COUNTY OF SAN BERNARDINO

March 7, 2000

Re: Comments on DEIR/DEIS for Cadiz Groundwater Storage and Dry-Year
County of San Bernardino's Supply Program (SCH No. 99021039)

**CALIBRATED VALUES OF TRANSMISSIVITY FOR
AN ALTERNATIVE GROUNDWATER MODEL**

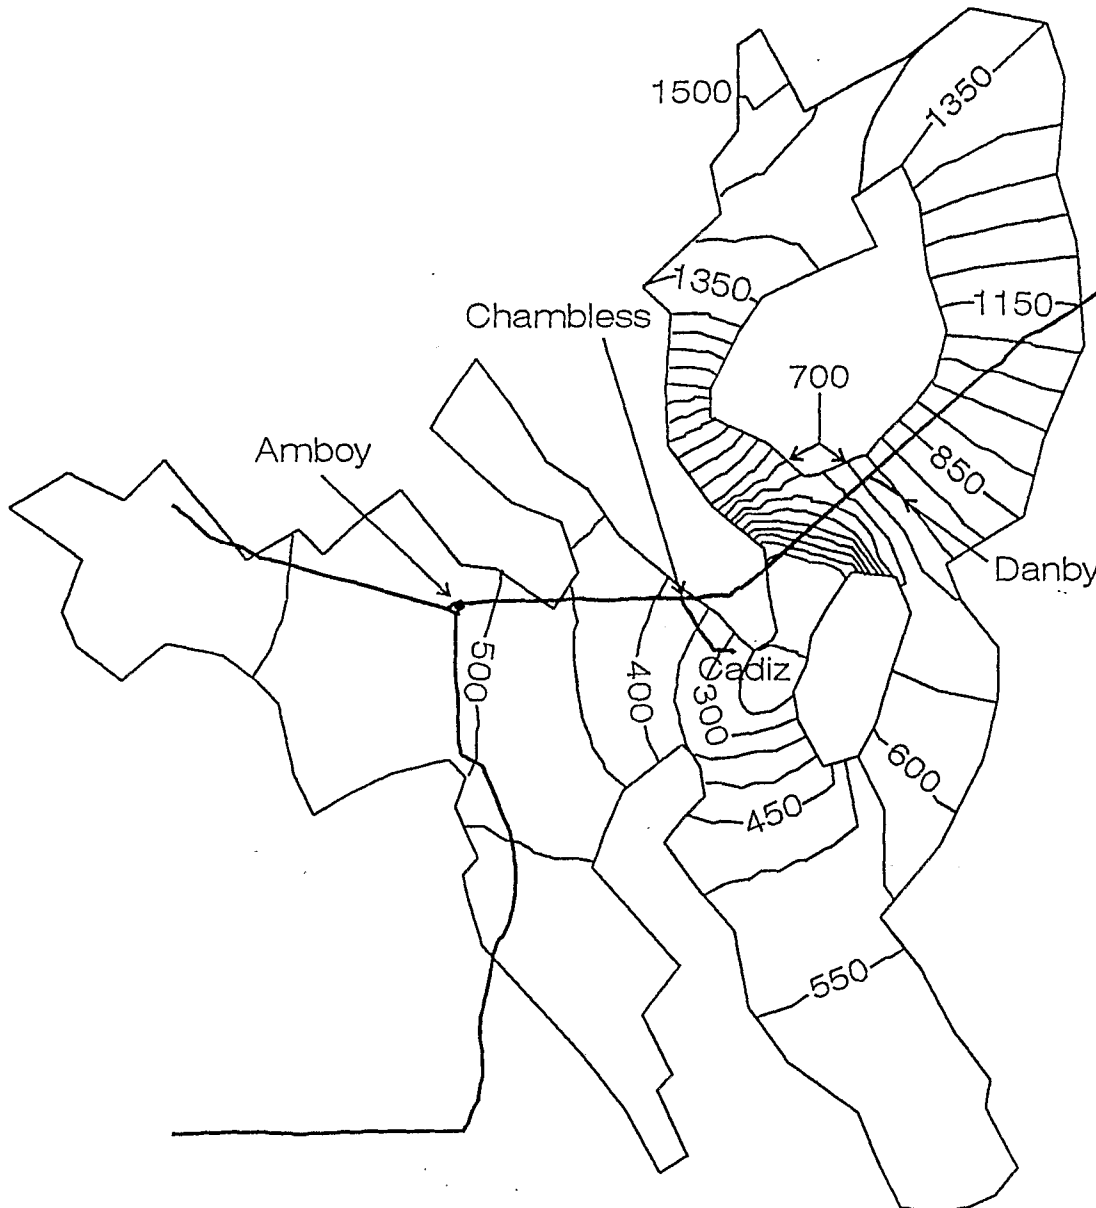
The Draft EIR/EIS indicates that the Project will produce only small impacts on groundwater levels over the 50-year project life. However, the alternative groundwater model indicates the opposite. Using the alternative groundwater model to simulate Scenario 6, the change in groundwater levels resulting from the implementation of the Project is shown on Figures 5 through 13. These maps and graphs indicate that large regional changes in groundwater levels will occur throughout Cadiz and Fenner Valleys as a result of the Project. These results completely contradict those reported in the Draft EIR/EIS (GeoScience, 1999). The Draft EIR/EIS states that the long-term change in regional groundwater levels will be less than 1 foot below Bristol Lake. If the groundwater model developed by GeoScience (1999) had been correctly conceptualized and calibrated, the simulation results from that model would have been like those produced by the alternative model. Because it was incompletely conceptualized and incorrectly calibrated, the model simulations produce a meaningless assessment of the expected project impacts. Accordingly, the model simulations cannot be relied upon.

CHANGE IN GROUNDWATER LEVELS RESULTING FROM THE CUMULATIVE IMPACT OF COMBINED PROJECT AND FARMING OPERATIONS AFTER 50 YEARS

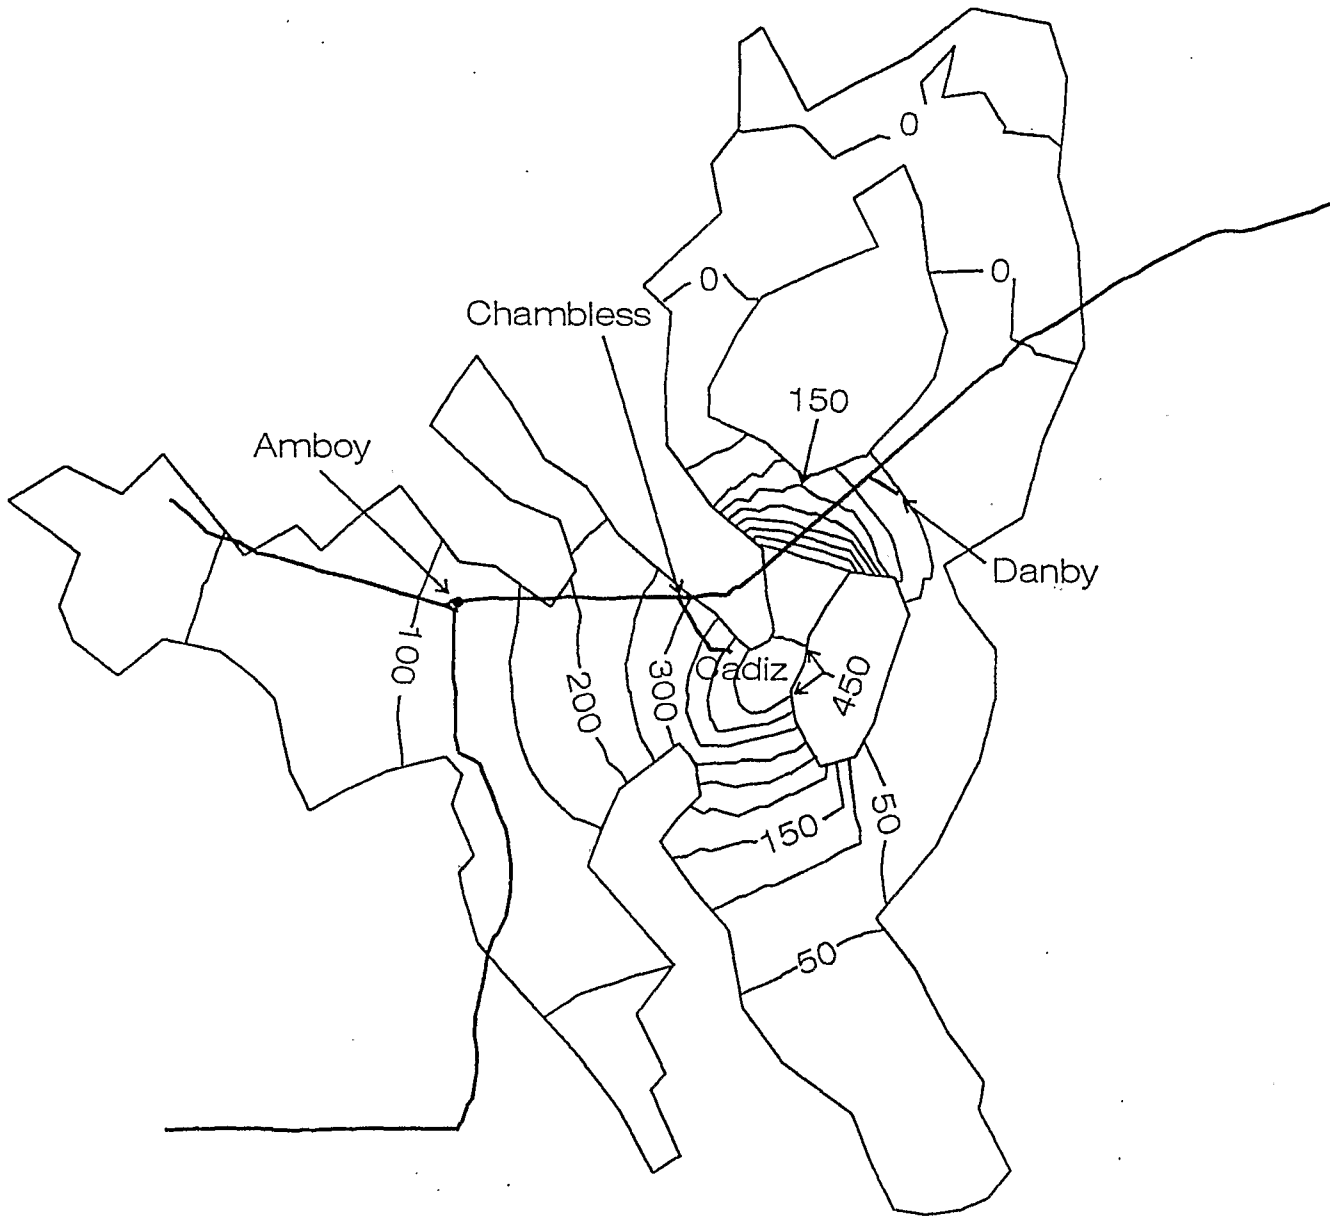
per year of local groundwater at full operational buildout by the approved agricultural operation of Cadiz Inc., the document erroneously states at pages 7-2 that "there are no locally planned, approved or reasonably anticipated land development projects in the vicinity of the Cadiz [Groundwater Storage, sic.] Project." The fact that Cadiz Inc. is an acknowledged partner in the Cadiz Groundwater Storage Project, and that the 1993 EIR for the Cadiz Agricultural project was referenced in Section 5.2, "Land Use, Planning and Policies" at page 5-10, points to an obvious failing in this section to disclose the cumulative effect of the MWD Cadiz Groundwater Project when combined with the Cadiz Inc. agricultural operation. The failure to acknowledge the large amount of groundwater required to support the level of agricultural production addressed in the certified 1993 EIR is erroneous and appears to be an attempt to minimize the potential cumulative impacts on indigenous groundwater. The failure to disclose the potential extraction of native groundwater for agricultural purposes is further exacerbated by the substantial overestimates of natural recharge to the Cadiz Groundwater Basin. The conclusionary statements in Section 7.5.5, "Water Resources" asserting that the Cadiz Project would not cause any significant cumulative hydrologic impacts fails to recognize the potential impacts of the Cadiz Inc. agricultural operation, and are fundamentally flawed based on inaccurate methodology used in the hydrologic analysis reported in the technical appendices. These critical omissions result in a failure to analyze this potentially significant cumulative impact.
